18VARIANCE1080 DeSales High School Sign

Louisville Metro Board of Zoning Adjustment Public Hearing

Chris French, AICP, Planning Supervisor September 17, 2018

300 Foot Buffer Around Sign

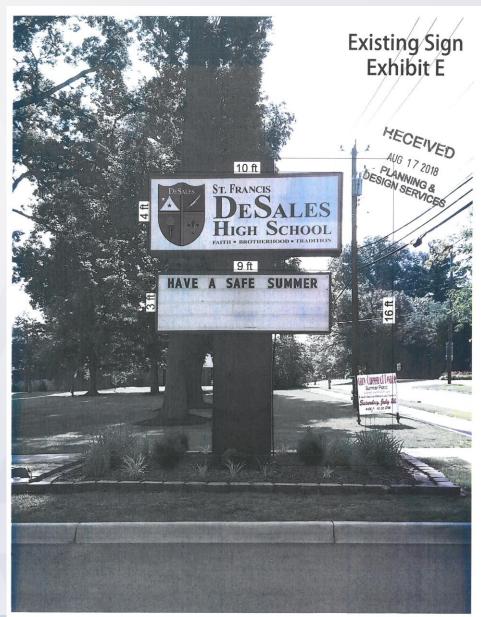
- Variance: from Land Development Code table 8.3.2 to allow a sign to exceed the allowed maximum height
- Variance: from Land Development Code table 8.3.2 to allow a sign to exceed the allowed maximum area
- Waiver: from Land Development Code section 8.2.1.D.4.a to allow a changing image panel to exceed 30% of the area of a sign
- Waiver: from Land Development Code section 8.2.1.D.6 to allow a changing image sign to be closer than 300 feet to residential properties

- The variance request to exceed the maximum height appears to be adequately justified and meets the standard of review.
- The variance request to exceed the maximum area appears to be adequately justified and meets the standard of review.
- The waiver from section 8.2.1.D.4.a appears to be adequately justified and meets the standard of review.
- The waiver from section 8.2.1.D.6 appears to be adequately justified and meets the standard of review.

Elevation

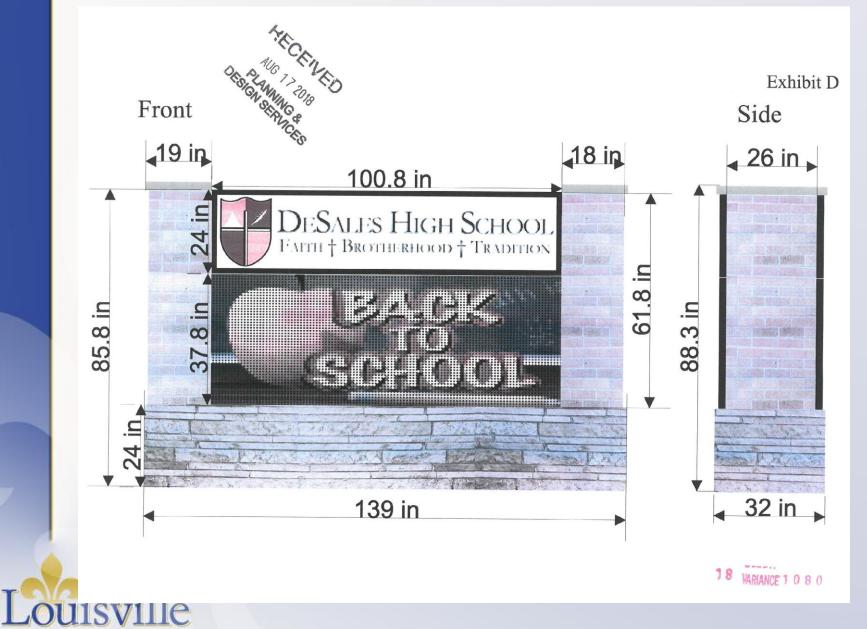
Location	Requirement	Request	Variance
Į	Sign Height	6 ft.	7.15 ft.	1.15 ft.
(Sign Area	32 sq. ft.	59.57 sq. ft.	27.57 sq. ft.
